Recycling & Recovery

RE: SSD7267 Mod 2 - Response to Submissions

Re: SSD 7267 Wetherill Park Transfer Station, – Civil Engineering Design

Figure 7: Part Site Plan – Fire Sprinkler System

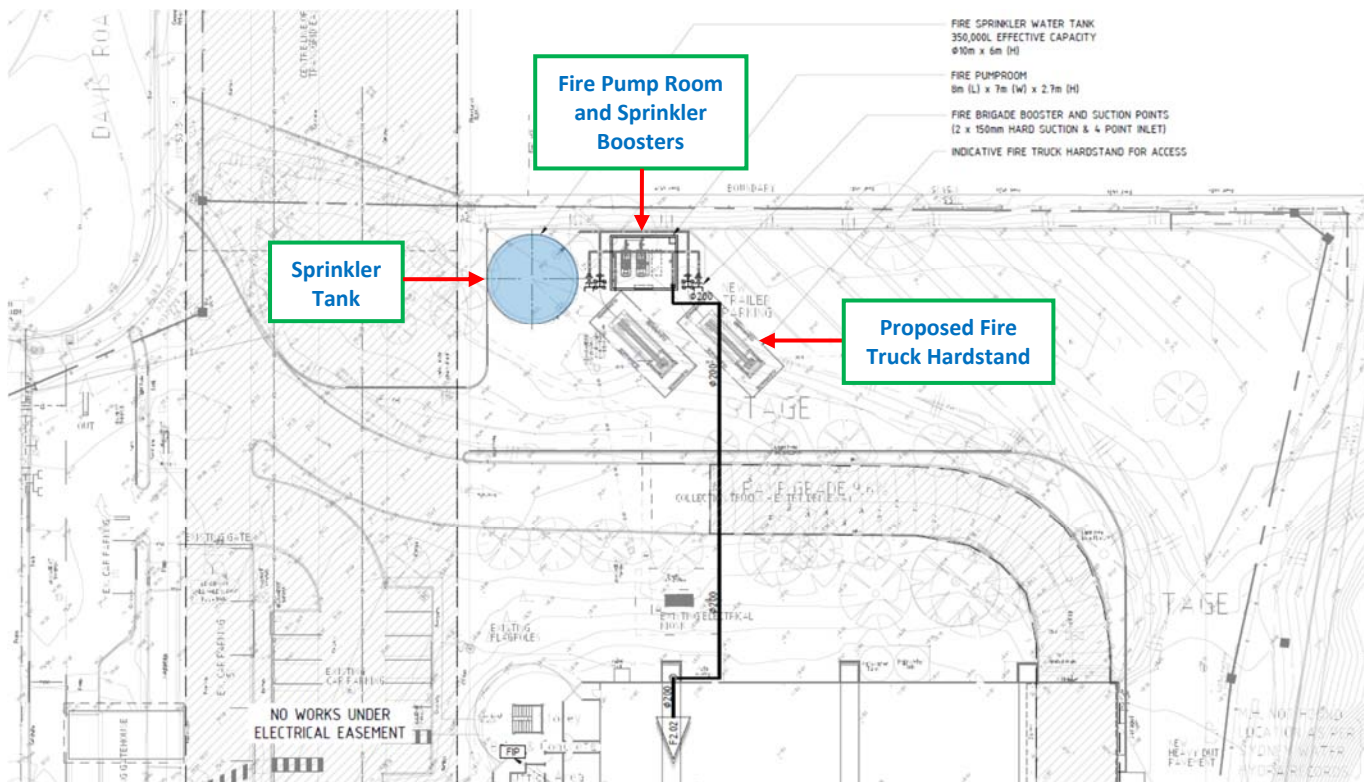
Note to FRNSW: We request FRNSW to advise / confirm that the proposed location of the hardstand for the fire brigade pumping appliances will meet the operational requirements of FRNSW. In principle support is provided

Figure 8: Part Site Plan – Fire Hydrant System

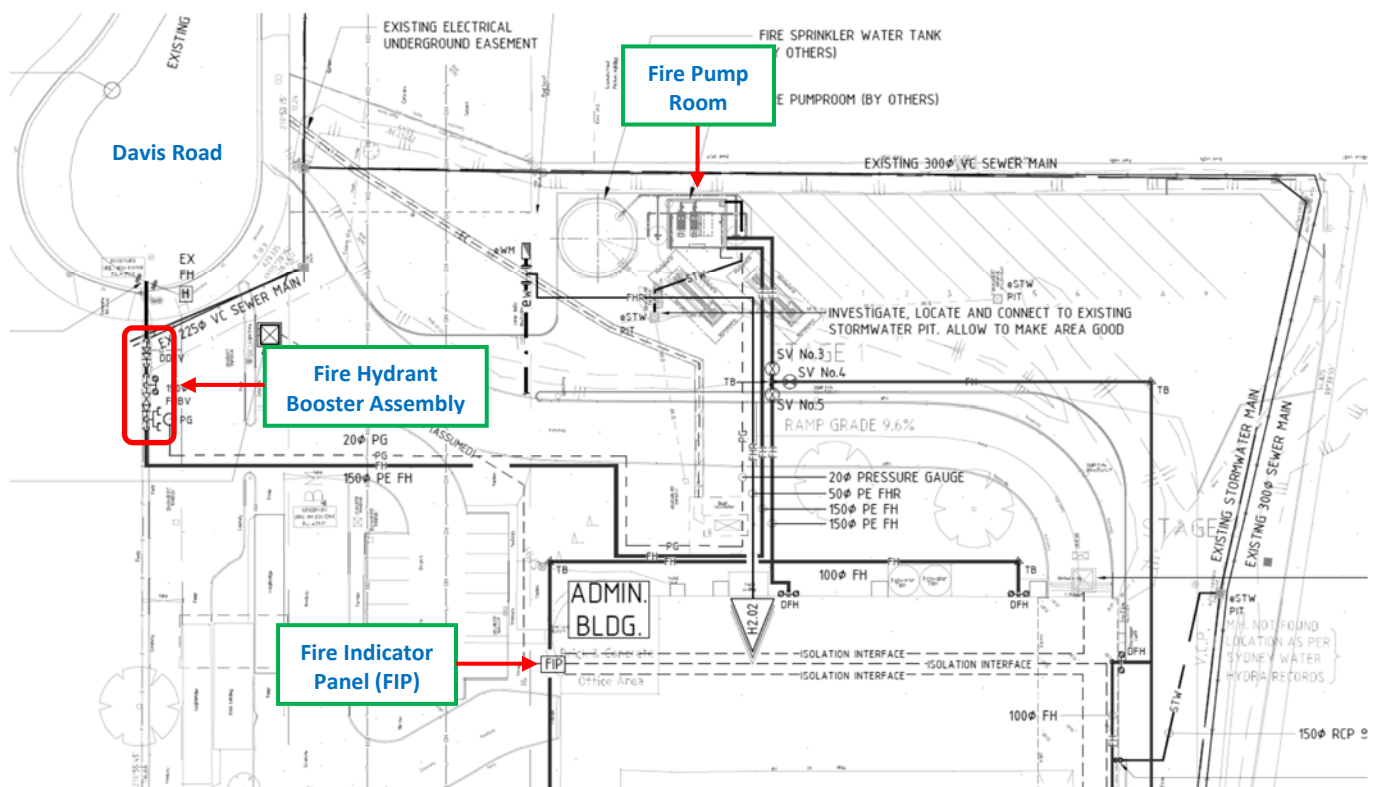
Note to FRNSW: We request FRNSW to advise / confirm whether the location and / or orientation of the fire hydrant booster assembly as shown in Figure 8 will meet the operational requirements of FRNSW. The booster assembly will be orientated to be perpendicular to the Davis Road frontage, but parallel to the perimeter access road around the building.
